## **Access Compliance Report Public Rights-of-Way** (Curb Ramps)

Intersection ID: 10022634 Main Street: CARMEL RD **Cross Street: N/A** Location: NE Initial Pass/Fail: Fail ADA ID: 71614AEF759B Ramp Type: PerpDiag **Overall Compliance: No** Severity Score: 21.25

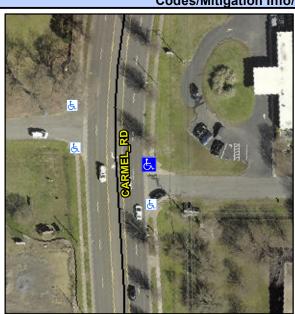
Street 1 Name **CARMEL RD** Stop Condition-Street 2 None Street 2 Name **ENTRANCE** Stop Condition-Street 1 None Possible Solutions: Remove & Replace Curb Ramp With **Two New Directional Ramps or** Equivalent. Surveyor Notes: N/A PROW/ADA: R304.5.1, R304.5.3

Field Measurements/Component Compliance						
Compliance Description		Data	Compl	iance	Description	Data
N/A	Ramp Length (in)	56.0	Yes Ramp Slope (%)		5.3	
No	Ramp Width (in)	40.0	No	Ramp XSlope (%)		5.8
N/A	Flare Type LT	N/A	N/A	Flare Type RT		N/A
N/A	Flare Slope LT (%)	N/A	N/A	Flare Slope RT (%)		N/A
N/A	Flare Traversable LT?	N/A	N/A	Flare	Traversable RT?	N/A
N/A	Landing Length (in)	N/A	N/A	DWS	Provided?	N/A
N/A	Landing Width (in)	N/A	N/A	DWS	Contrast?	N/A
N/A	Landing Slope (%)	N/A	N/A	DWS	Length (in)	N/A
N/A	Landing X Slope (%)	N/A	N/A	DWS	Full Width?	N/A
N/A	Landing Curb? (Y/N)	N/A	N/A	DWS	Offset (in)	N/A
N/A	Shared Landing?	N/A				
N/A	Gutter Ponding?	N/A	N/A	Gutte	r Slope (%)	N/A
N/A	Gutter Lip Ht (in)	N/A	N/A	Gutte	r X Slope (%)	N/A
N/A	Painted X Walk1?	No	N/A	Paint	ed X Walk2?	No
	X Walk 1 Direction	To W		X Wa	lk 2 Direction	To SW
N/A	X Walk 1 Width (in)	N/A	N/A	X Wa	lk 2 Width (in)	N/A
	X Walk 1 Slope (%)	5.0		X Wa	lk 2 Slope (%)	3.7

X Walk 1 X Slope (%)	2.9		X Wa	lk 2 X Slope (%)	7.0
N/A	Ramp inside XWalk1?	N/A	N/A	Ramp	inside XWalk2?	N/A
	Road Slope (%)	1.9	N/A	Clear	Space?	N/A
	Road X Slope (%)	5.8	N/A	Clear	Space to XWalk (in)	N/A
N/A	Any Obstructions?	N/A	N/A	Storm	Grate/Utility Hazard?	N/A
	Obstruction Type			Storm	Grate/Utility Type	
		N/A				N/A
			Yes	Surfa	ce Condition? (G/P)	Good
10,47,9800 /60
